Tollway Standard Drawing Revisions

Section K	Temporary	Erosion & Sediment Control	
	Standard	Modification Summary	Effective: 03/11/15
	All	Revised detail descriptions to match Tollway Coded Pay Items	
		Updated drawings to follow IDOT highway standard levels

STANDARD K1-05

TEMPORARY EROSION

EMBANKMENT PHASING PLAN - FILL SECTION

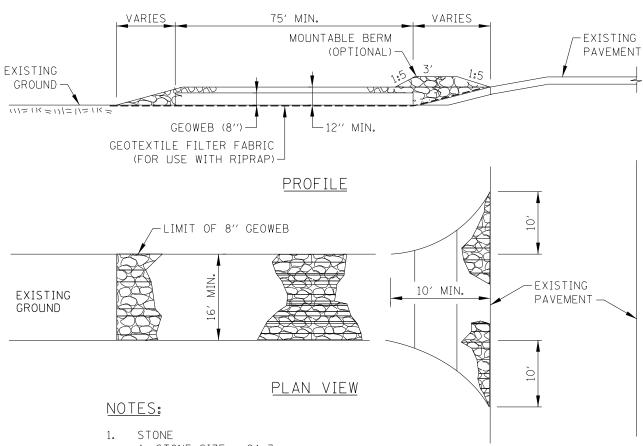
Sheet 3	Embankment Phasing Plan-Fill Section-Detail	
	Officer 5	Deleted note 2B, changed 2A to 2.	
		Deleted note 2B, changed 2A to 2.	
	Sheet 4	Temporary Rock Check Dam-Detail	
		Added note 5

SYNTHETIC POROUS RUNOFF CONTROL STRUCTURE STANDARD SYMBOL

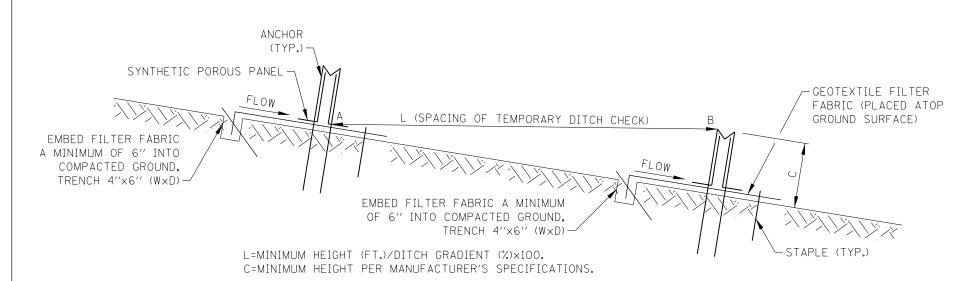
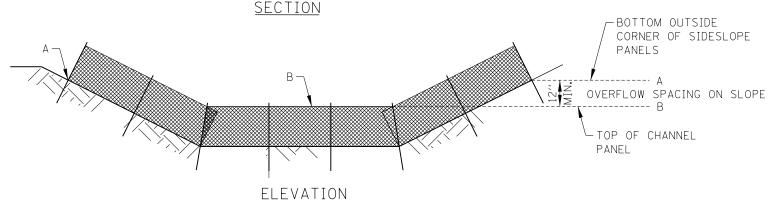
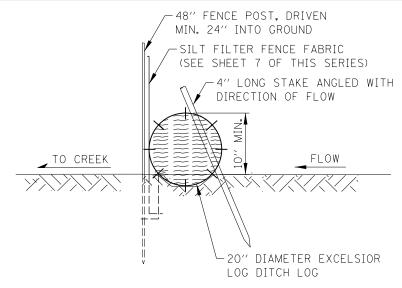
Sheet 6	Synthetic Porous Runoff Control Structure-Detail	
		Added dimension "C" for panel height to detail	
		Creek Buffer Strip and Silt Fence-Detail	
		Note 1. Deleted second sentence

SILT FENCE (SF) STANDARD SYMBOL

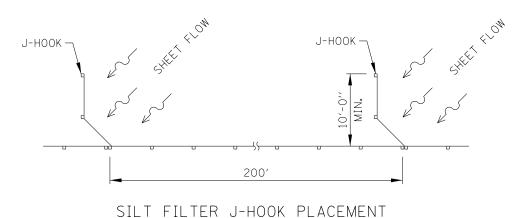
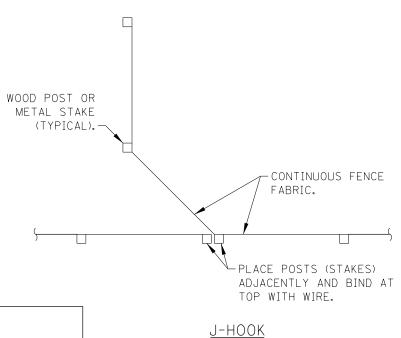
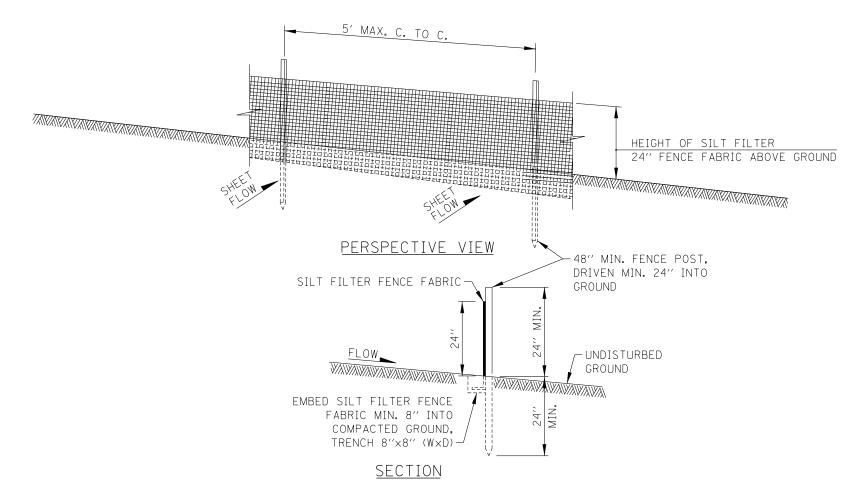
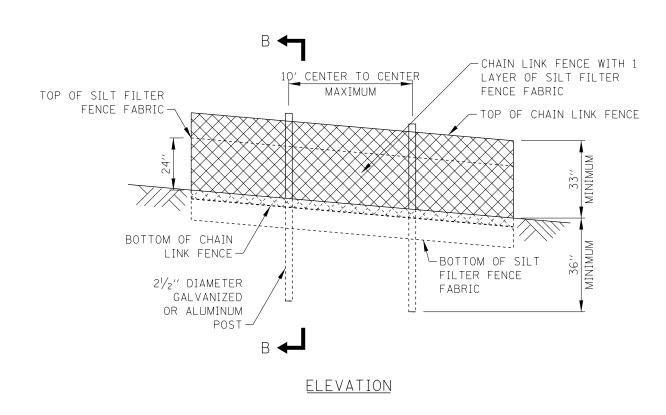
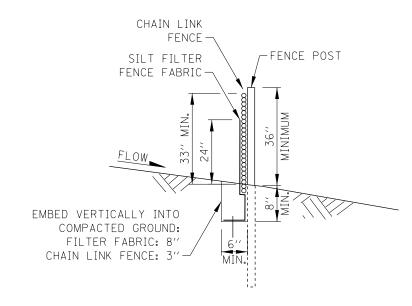
Sheet 7	Silt Fence-Detail	
	Sileet 1	Deleted note 5; Renumbered note 6 to 5	
		Deleted note 3, Nenumbered note 6 to 3	
	Sheet 8	Super Silt Fence-Detail	
		Deleted note 6; Renumbered note 7 to 6

CULVERT INLET PROTECTION - FENCE STANDARD SYMBOL

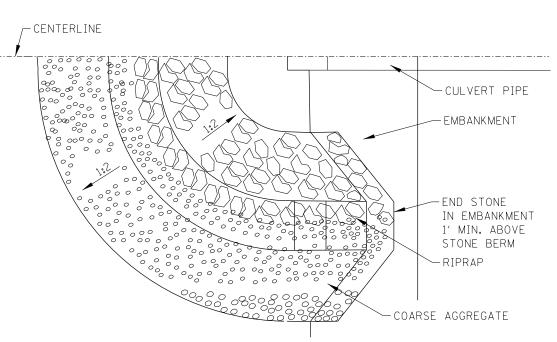
Sheet 9	Culvert Inlet Protection Fence-Detail	
		Note 1. Revised maximum post spacing from 6' to 3'	
	Shoot 10	Flotation Boom Detail	
	Silect 10	Revised drawing to show boom reaching bottom of waterway	
		revised drawing to show boom readining bottom or waterway

- 1. CONSTRUCT SUPER SILT FENCE PER SHEET 8 IN THIS SERIES, EXCEPT THE MAXIMUM POST SPACING SHALL BE 3 FEET AND THE TOPS OF POSTS SHALL BE CROSSED BRACED.
- 2. MAINTENANCE SHALL BE PERFORMED AS NEEDED. SEDIMENT SHALL BE REMOVED WHEN IT REACHES 50% OF THE FENCE HEIGHT.
- 3. THE CULVERT INLET PROTECTION AND SEDIMENT SHALL BE REMOVED WHEN CONSTRUCTION IS COMPLETE.
- 4. THE CULVERT INLET PROTECTION FENCE TO BE MEASURED AND PAID FOR AS SUPER SILT FENCE.

FILTER FABRIC INLET PROTECTION

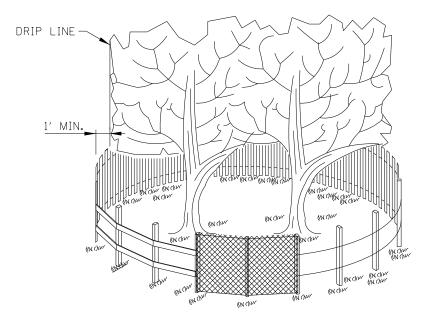
Sheet 11	Filter Fabric Inlet Protection-Detail	
		Added new symbol for "Filter Fabric Inlet protection, Cover Type	
		Added new symbol for "Filter Fabric Inlet protection, Basket Type
